From: Benzie, Richard (DEQ)
 To: [Cooks, Pat \(DEQ\)](#)
 Subject: FW: Flint schematic in OEL
 Date: Friday, October 02, 2015 4:00:00 PM
 Attachments: [image002.png](#)

From: Crooks, Jennifer [mailto:crooks.jennifer@epa.gov]
 Sent: Friday, October 02, 2015 12:46 PM
 To: Busch, Stephen (DEQ); Prysby, Mike (DEQ); Rosenthal, Adam (DEQ); Benzie, Richard (DEQ)
 Cc: Poy, Thomas
 Subject: Flint schematic in OEL

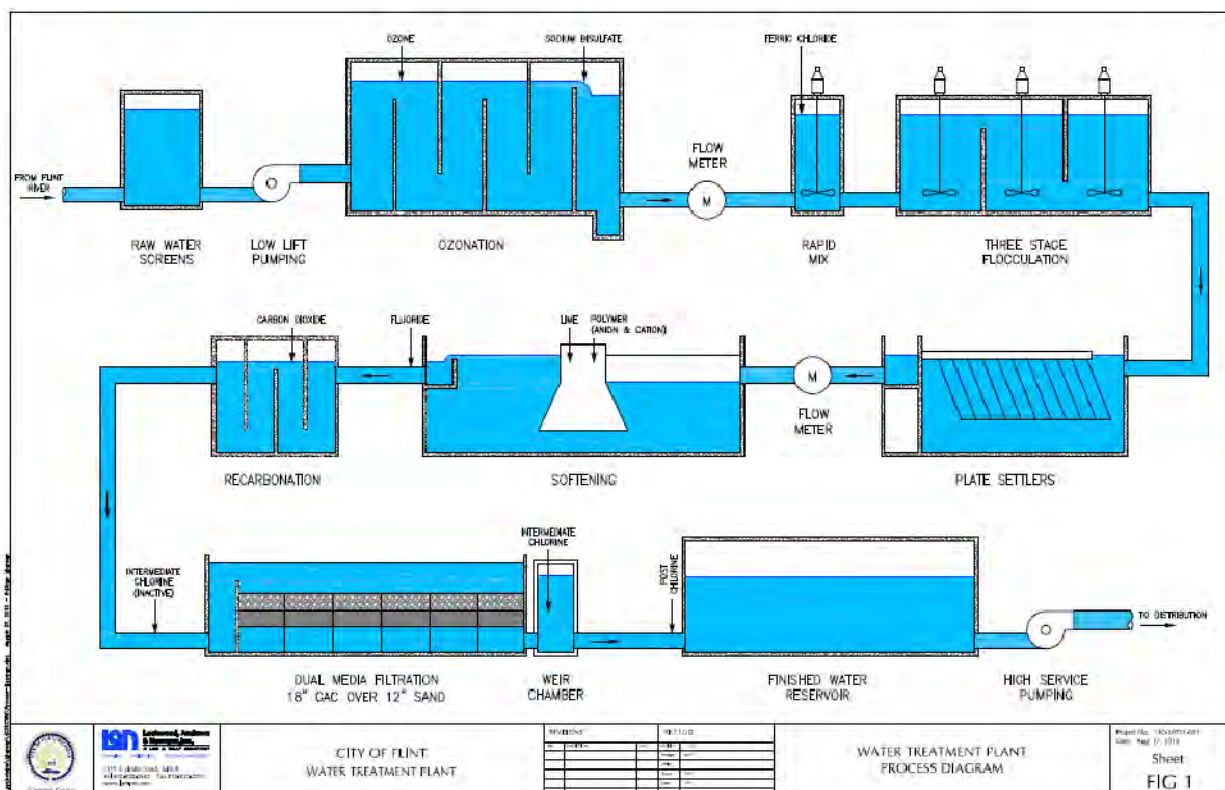
Have we routinely allowed filter plants to have only 12-inches of sand in there dual-media filters?
